RESOLUTION NO. 44-2022

CONDITIONALLY APPROVING THE SCHEMATIC DESIGN OF A MIXED-USE AFFORDABLE HOUSING PROJECT OF APPROXIMATELY 151 RENTAL UNITS FOR SENIORS AND APPROXIMATELY 2,945 SQUARE FEET OF COMMERCIAL SPACE AT THE WESTERN HALF OF BLOCK 2 OF ZONE ONE OF THE TRANSBAY REDEVELOPMENT PROJECT AREA; TRANSBAY REDEVELOPMENT PROJECT AREA

EXHIBIT A: Schematic Design Document for the Transbay Block 2 West Project

Schematic Design Document

Block 2 Project Loading Scenario

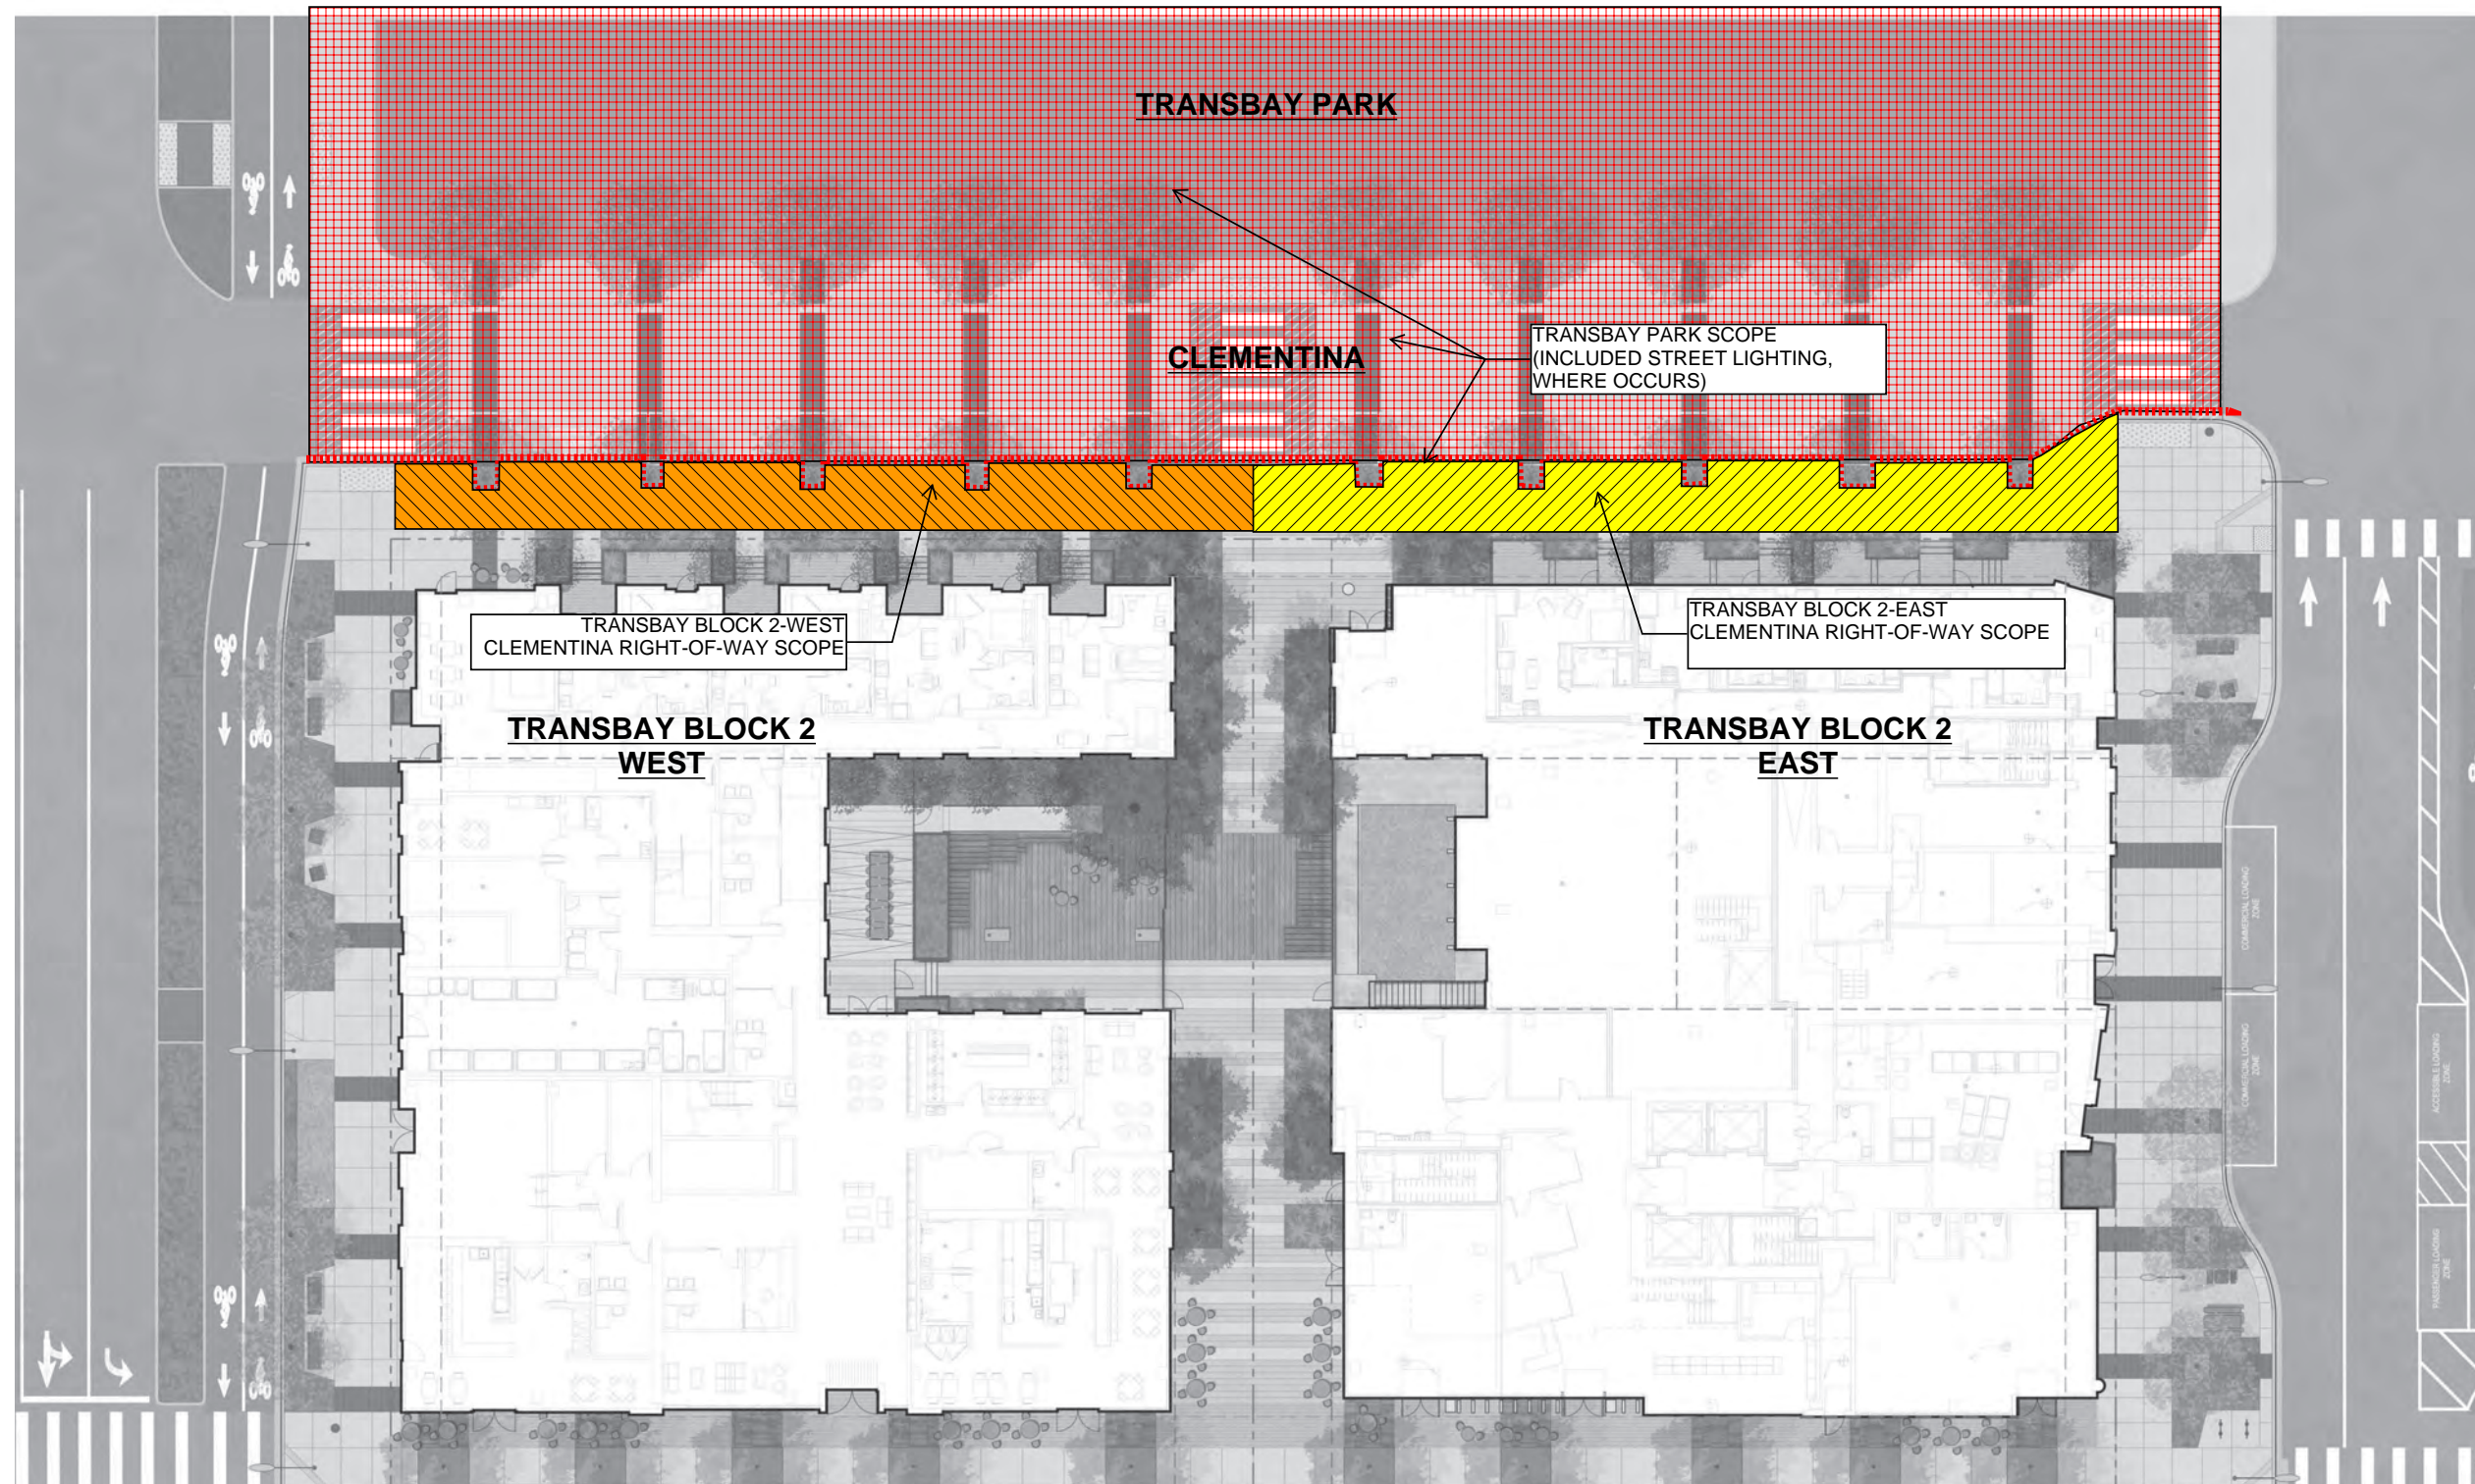
WHEREAS, The Development Controls allow the Agency to establish a lower ratio of off-street loading spaces than what would otherwise be required, based on a development-specific loading scenario. The Development Controls require a ratio of one off-street loading space for a development the size of the Block 2 Project. The Co-Developers prepared a development-specific loading scenario that proposed the Block 2 Project’s loading demand be met at designated on-street loading spaces surrounding the Site without the provision of an off-street loading space, curb cut or driveway (“Block 2 Project Loading Scenario”). The Block 2 Project Loading

Scenario is on page 84 of the 2 West Project Schematic Design Document and has been reviewed by OCII staff, by City staff at the San Francisco Public Works and San Francisco Municipal Transportation Agency departments, and by representatives of the City's waste management contractor, Recology, who have determined that the Block 2 Project Loading Scenario adequately fulfills the requirements to meet the Block 2 Project's future demand for commercial and residential loading, ongoing commercial and residential pick-up and delivery of goods and waste products, and passenger pick-up and drop-offs, without the need for an off-street loading space on the Site; and,
